March 18, 2025

Re: Briohn Land Development - Corporate Drive/Lot 3 of CSM No. 10428

On behalf of the City of Waukesha, we have reviewed the application documents submitted 03/03/2025 by Briohn Design Group, LLC for site development of Corporate Drive/Lot 3 of CSM No. 10428.

C2.0

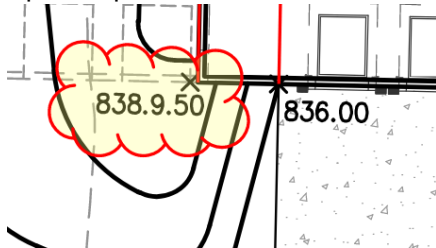
12. Update spot elevation on SW corner of building at loading dock:

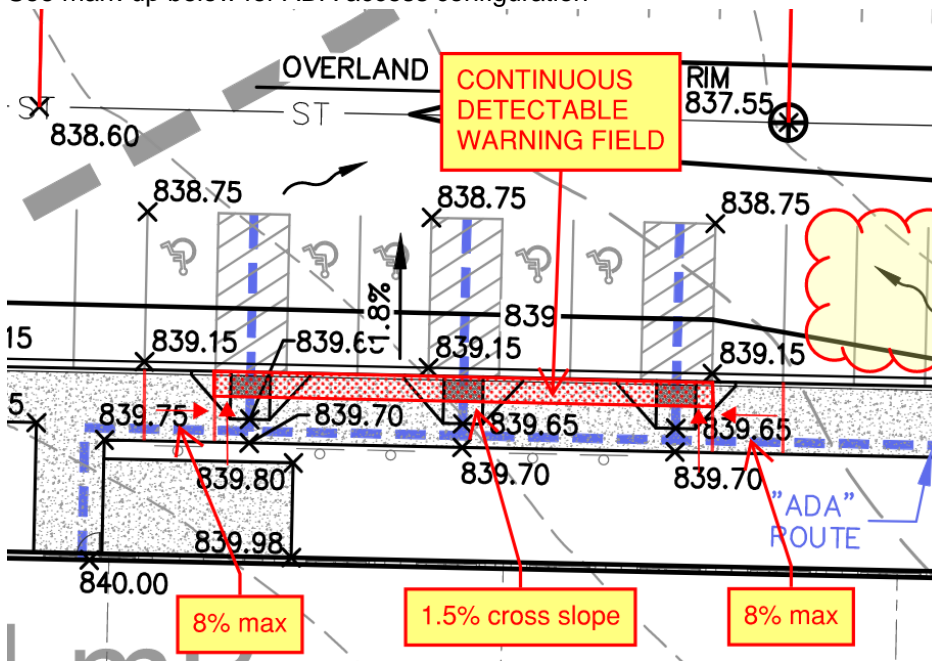
13. See mark-up below for ADA access configuration
